Technical Service Bulletin

TSB1118
Radiator Mounting CX65 2017 - 2018

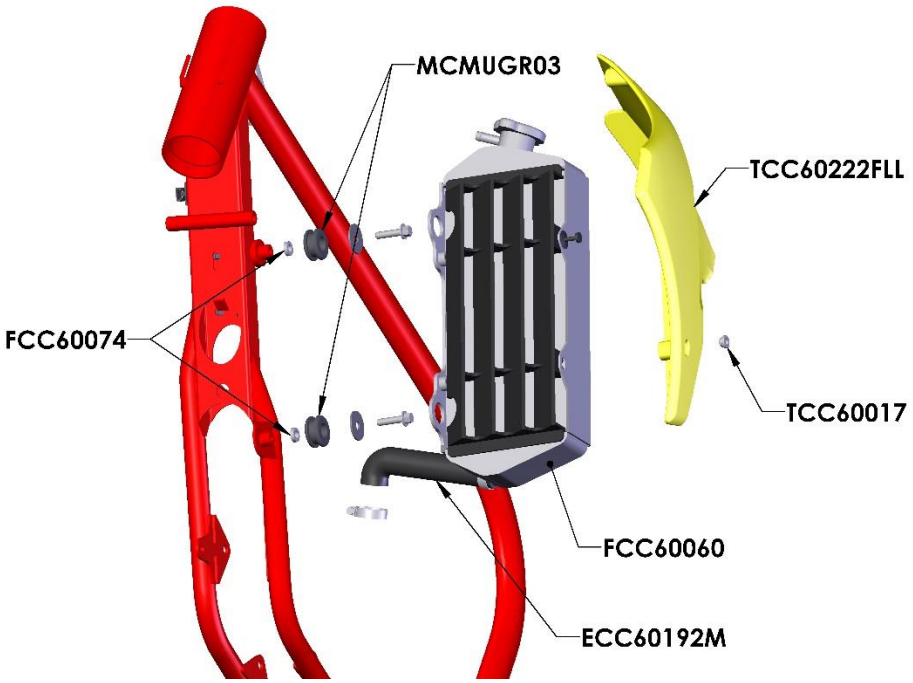
Issue:
Some customers are having issues with radiators leaking prematurely on 2017 – 2018 CX65.

Action:
Mounting the radiator less rigidly and taking strain off the bottom hose spigot with a kit of parts, FKC60002. Parts included in the kit are;

Parts included in FKC60002		
Part Number	Description	Quantity
FCC60060	RADIATOR CX65 2012-CURRENT	1
TCC60222FLL	SHROUD LEFT - FLO YELLOW CX65 - FLEX	1
MCMUGR03	GROMMET – EXTRA WIDE	2
TCC60017	WASHER - 5MM BODY PANEL	1
ECC60192M	HOSE - LOWER RADIATOR	1
FCC60074	SPACER – EXTENSION for FRAME MOUNT	2
